FLORIDA DEPARTMENT OF ENVIRONMENTAL PROTECTION

Re: **Request for Additional Information**
Project No. 0250020-035-AC
Tarmac America, LLC, Pennsuco Cement Plant
Request to Revise Certain Permit Conditions and Construction of a Clinker Conveyor Line

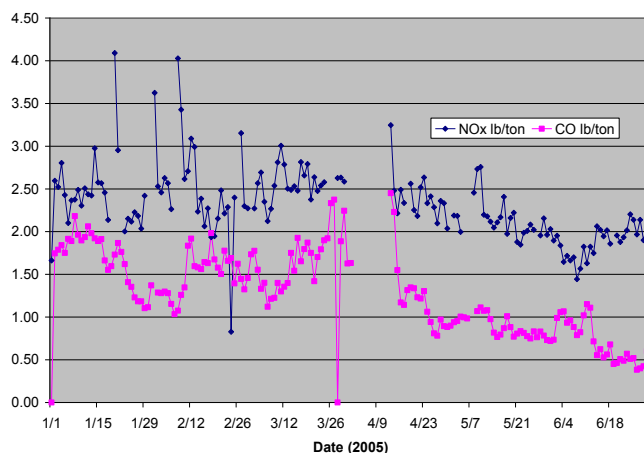
1. Tarmac requests to delete the short term NO_x emission limit of 720 lb/hr based on a 24-hr block average.

To evaluate this request, please submit a chart representative of the continuous emissions monitoring (CEM) for NO_x (2 years representative period) including short and long term data. The summary chart example below is taken from the 2005 technical evaluation and preliminary determination (TEPD) for this pollutant.
